**BEFORE THE HON'BLE NATIONAL GREEN TRIBUNAL
WESTERN ZONE BENCH AT PUNE
ORIGINAL APPLICATION NO. 28 OF 2020 (WZ)**

**AFFIDAVIT-IN-REPLY ON BEHALF OF THE RESPONDENT NO.6 TO THE
ORIGINAL APPLICATION NO.28/2020**

**Point wise Reply to the MoM dated 20th Nov,2019 in the matter of
Sarang Yadwadkar (Applicant)**

Annexure 2 -Revised Layout of Metro Piers

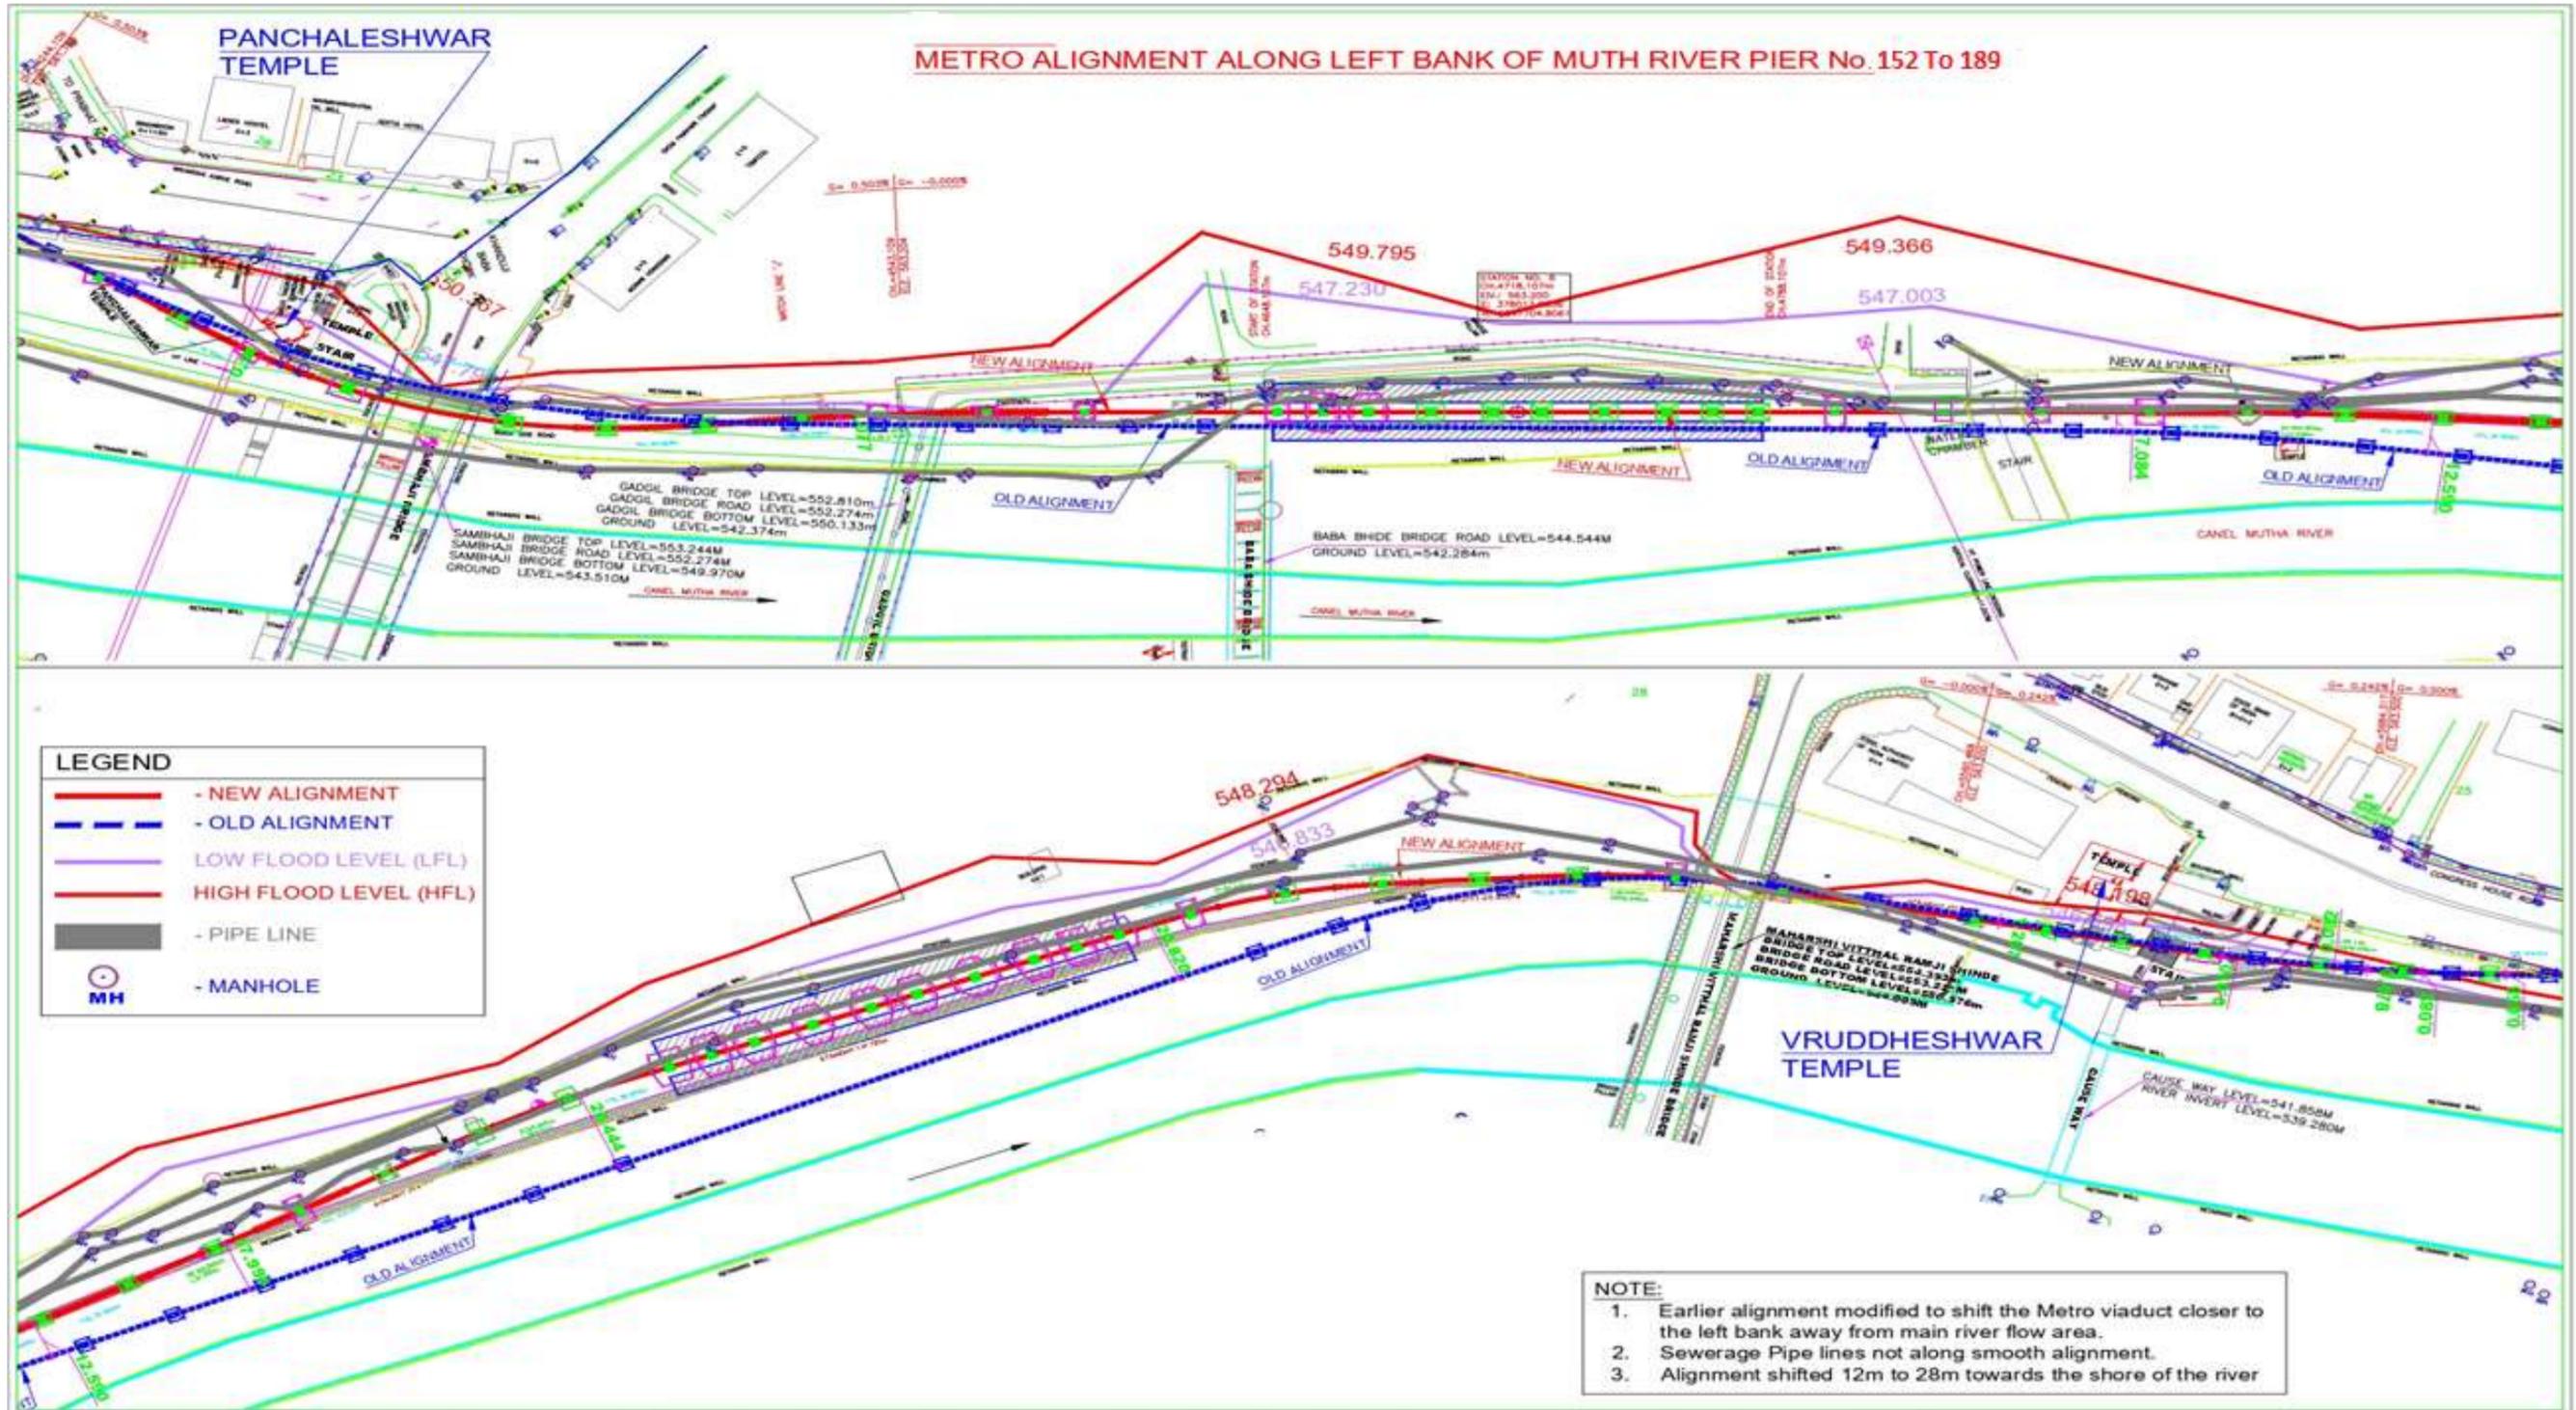
In this area there are two large diameter embedded sewerage lines which could not be disrupted (as it could have caused very serious river contamination) thus a structural scheme became necessary to support the single column piers of the viaduct on foundations which span the pipelines by providing piles and pile caps whose bottom is clear of the top of the pipeline. The modified design had piles and pile caps (above the bed level), albeit the width of the piers was slightly reduced (**Annexure -3**). These were shared with the NGT Expert Committee members during their visit on 30.11.2018. The sewerage pipelines are not in a smooth alignment while Metro requires a smooth alignment and therefore this solution had to be adopted for 31 foundation locations (out of a total of 60 locations). At these locations the pile caps are above the bed level along the left bank. However, the flow velocity of the river at these locations is much less than in the central zone causing comparatively less obstruction due to pile caps.

Initial mathematical studies of river flow at the pier locations were carried out without pile foundations embedded in the riverbed. The calculated local afflux at SP 10 (Sambhaji station pier -10) worked out to 11.7 mm. When the design underwent modification and pile caps were proposed laid on the river bed the mathematical computations of afflux were reworked. The maximum local afflux thus worked out is at SP8 (Sambhaji station Pier) was 29.2 mm. This was worked out for a discharge of 100,000 cusecs and was presented to the Expert Committee of NGT on 30.11.2018.

Subsequently in the matter other NGT order dated 5.11.2019 (Application No.70/2019(WZ) highlighted that the width of the river has been misinterpreted. On verification it was found that due to manual digitisation of pdf file an error had indeed occurred which has now been rectified by using the recent data from irrigation department. The results of the revised mathematical analysis based on the above are as follows.

This has now been corrected and the revised mathematical calculations are presented the data for which includes raised foundations and piers.

Annexure 2 -Revised Layout of Metro Piers

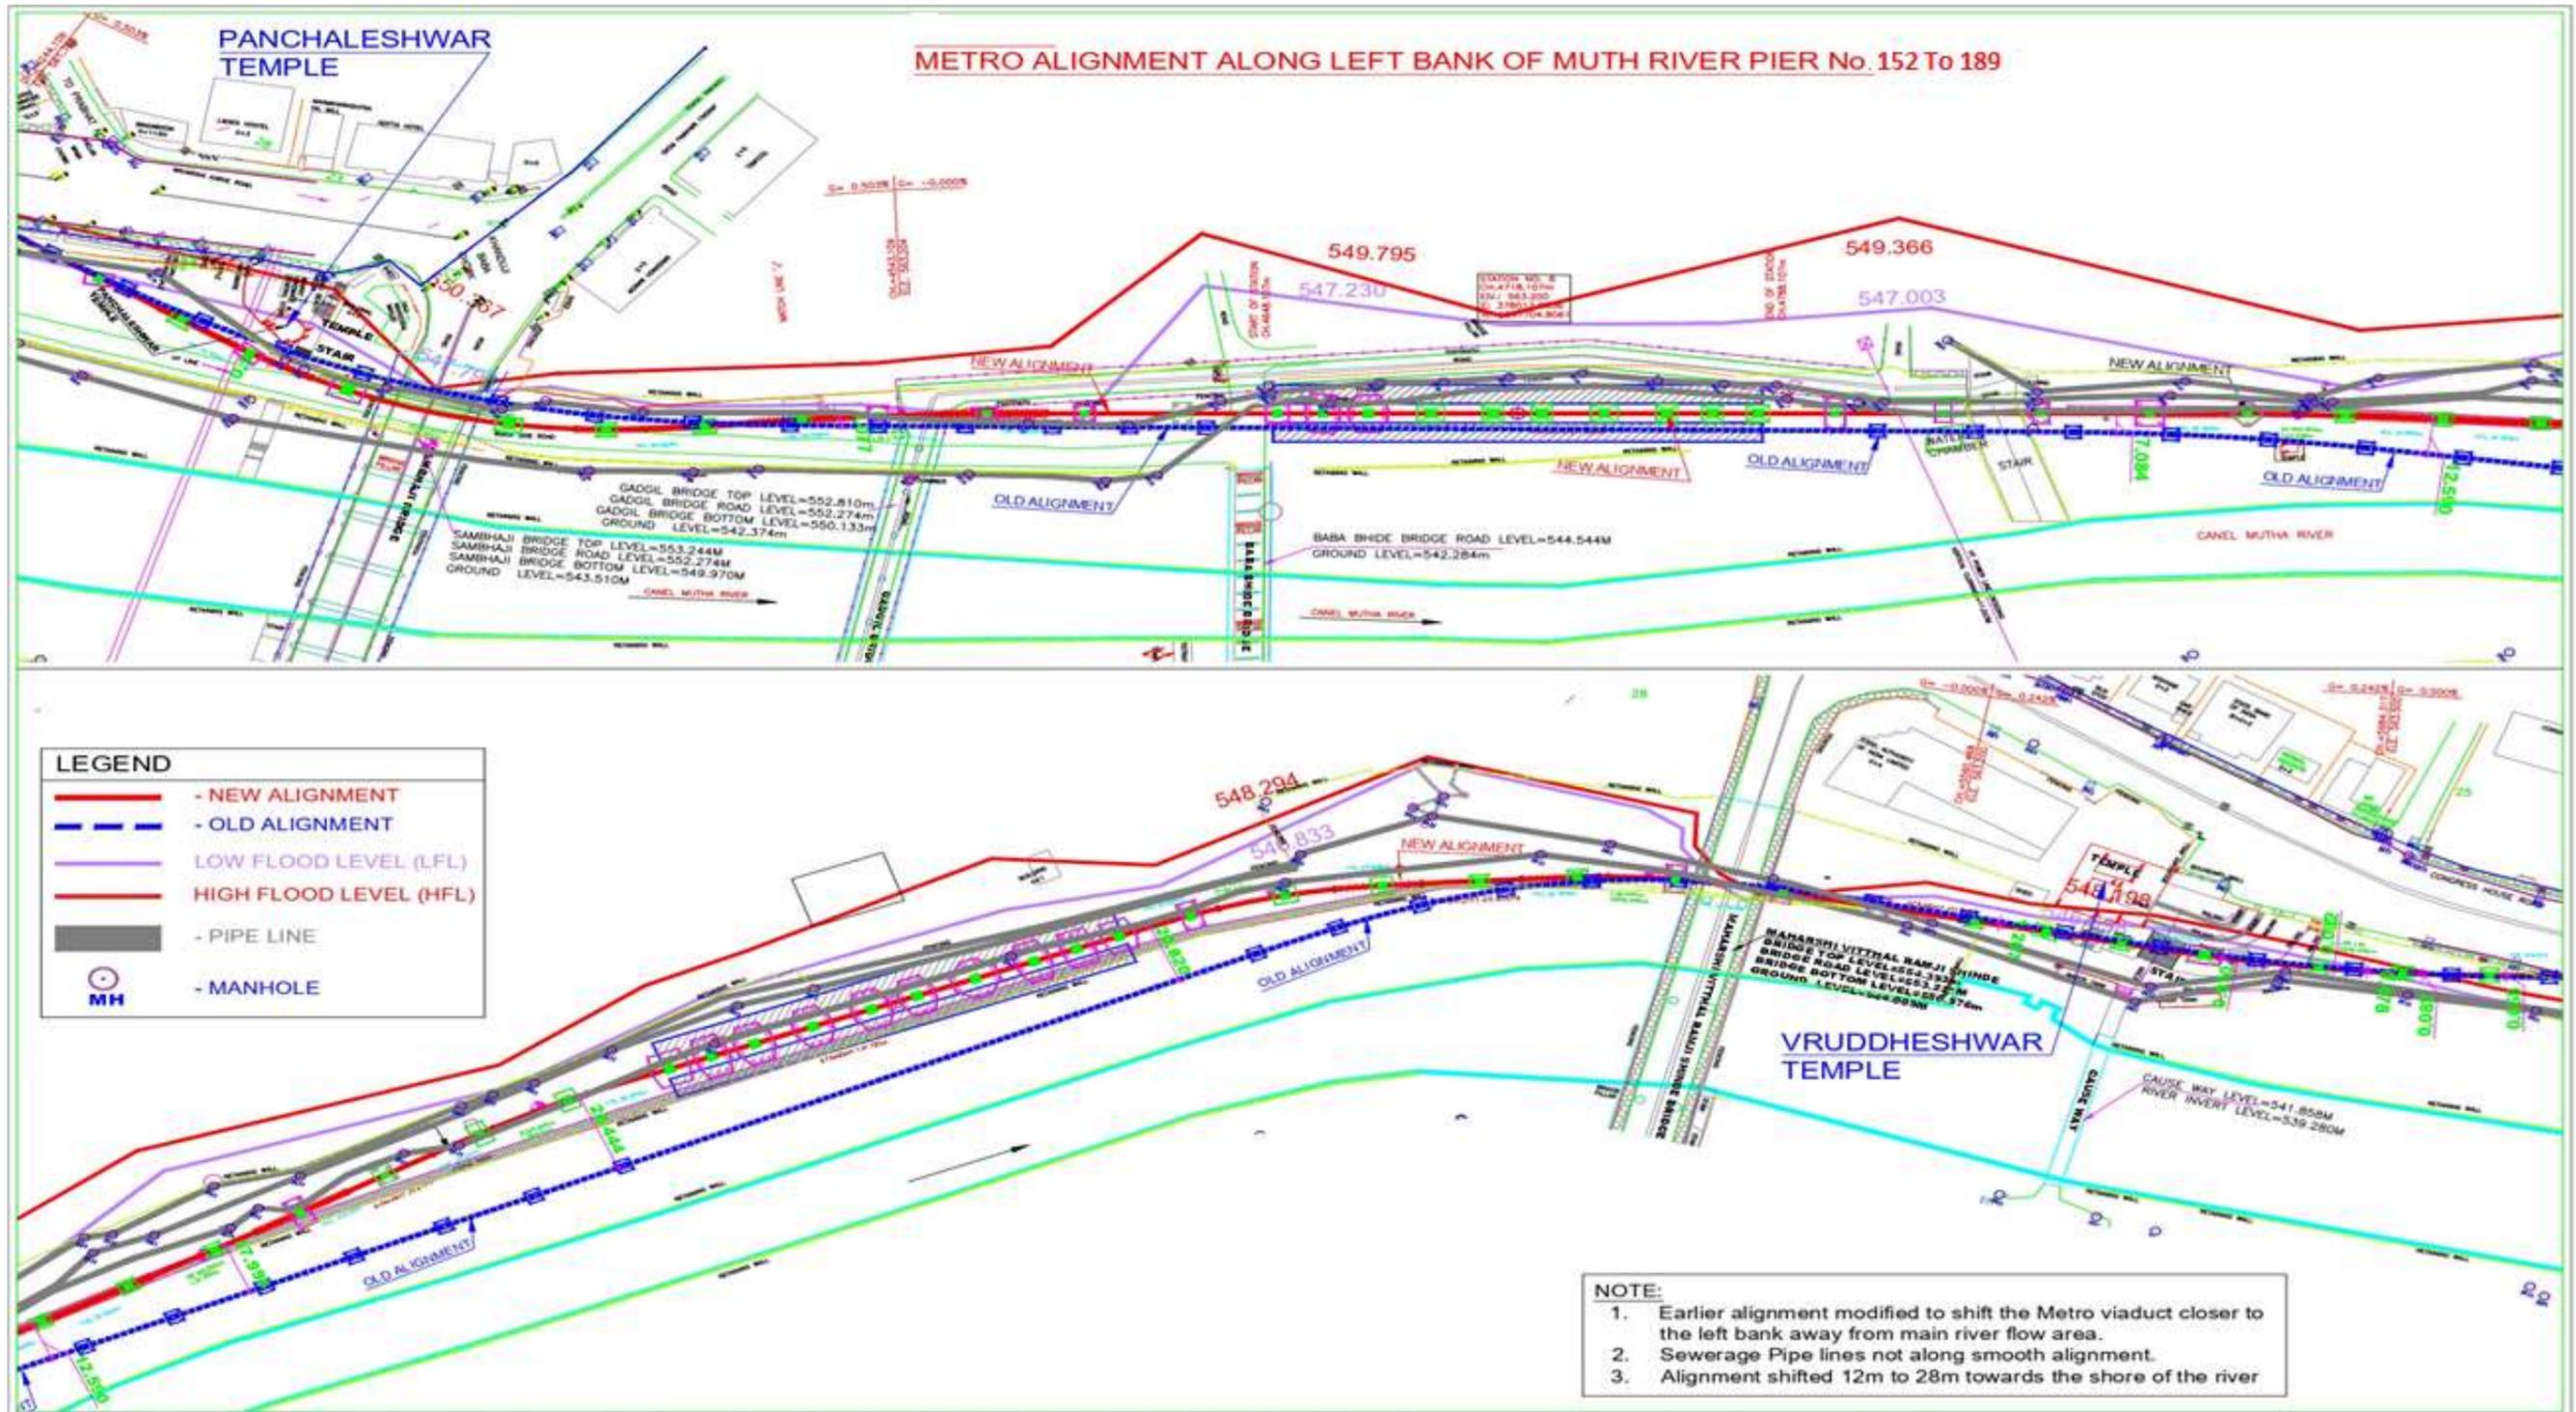
In this area there are two large diameter embedded sewerage lines which could not be disrupted (as it could have caused very serious river contamination) thus a structural scheme became necessary to support the single column piers of the viaduct on foundations which span the pipelines by providing piles and pile caps whose bottom is clear of the top of the pipeline. The modified design had piles and pile caps (above the bed level), albeit the width of the piers was slightly reduced (**Annexure -3**). These were shared with the NGT Expert Committee members during their visit on 30.11.2018. The sewerage pipelines are not in a smooth alignment while Metro requires a smooth alignment and therefore this solution had to be adopted for 31 foundation locations (out of a total of 60 locations). At these locations the pile caps are above the bed level along the left bank. However, the flow velocity of the river at these locations is much less than in the central zone causing comparatively less obstruction due to pile caps.

Initial mathematical studies of river flow at the pier locations were carried out without pile foundations embedded in the riverbed. The calculated local afflux at SP 10 (Sambhaji station pier -10) worked out to 11.7 mm. When the design underwent modification and pile caps were proposed laid on the river bed the mathematical computations of afflux were reworked. The maximum local afflux thus worked out is at SP8 (Sambhaji station Pier) was 29.2 mm. This was worked out for a discharge of 100,000 cusecs and was presented to the Expert Committee of NGT on 30.11.2018.

Subsequently in the matter other NGT order dated 5.11.2019 (Application No.70/2019(WZ)) highlighted that the width of the river has been misinterpreted. On verification it was found that due to manual digitisation of pdf file an error had indeed occurred which has now been rectified by using the recent data from irrigation department. The results of the revised mathematical analysis based on the above are as follows.

This has now been corrected and the revised mathematical calculations are presented the data for which includes raised foundations and piers.
